SSD7348 MOD 10, OAKDALE WEST STAGE – S.4.55(1A) APPLICATION TO MODIFY ARCHITECTURE PLANS

As the consent authority for SSD7348, the Department of Planning, Industry and Environment (DPIE) are authorised to modify the consent provided the above is met. This is the **tenth (10)** modification to SSD7348 and seeks to update Precinct 1 signage plans, including façade signage.

Figure 1 - Sign 1- approved

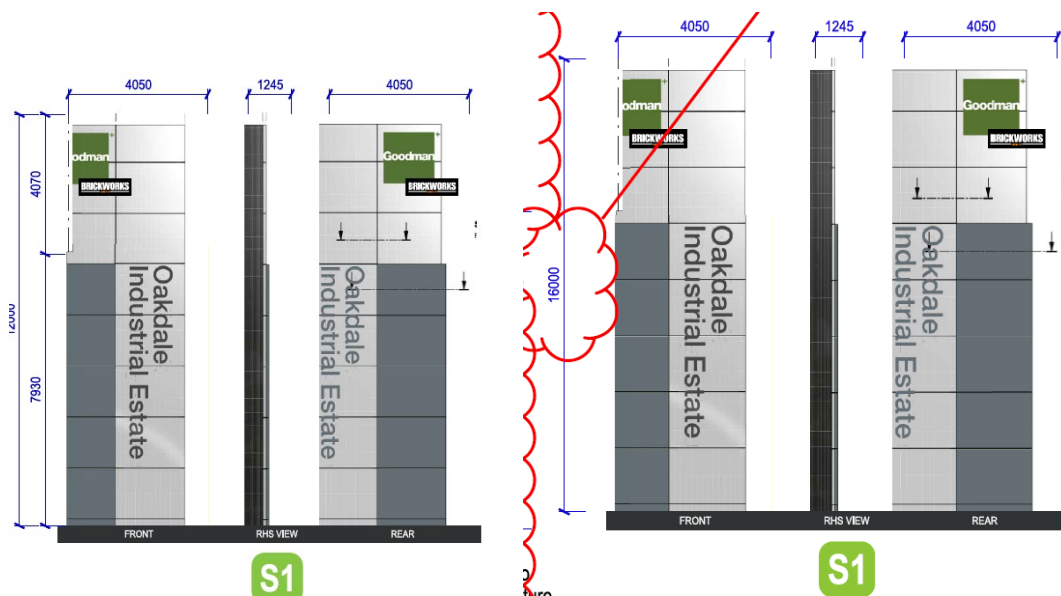
- 1) Pylon Sign (S1) sought for height increase from 12m to 16m height (refer **Figure 1**):
 - The proposed 16m height is considered more appropriately scaled considering the context, particularly the significant 36m adjacent Lot 1A warehouse.
 - The location of the S1 sign proposed to remain as approved.
 - The reason for the update is that the 16m sign would be too recessive considering the estate context.
- 2) Tenant façade signage “D” and “E” reduced in size as per customer request – refer **Fig.2**
- 3) Sign “E” removed from south-east corner office of warehouse 1A

The approved 12m S1 estate entry pylon sign is proposed to be increased in height from 12m to 16m in height. This will ensure the signage is appropriately proportioned in the context of the adjacent 36m warehouse.

- S1 signage location remains unchanged, located on the corner of the Western North South Link Road and Estate Road 1;
- The width and depth of the S1 signage remains unchanged and as approved;
- While an additional 4m signage height is proposed, when viewed in the context of the adjacent 36m warehouse building the visual impact is considered appropriate. The signage will remain 20m below the height of the adjacent Lot 1A warehouse.
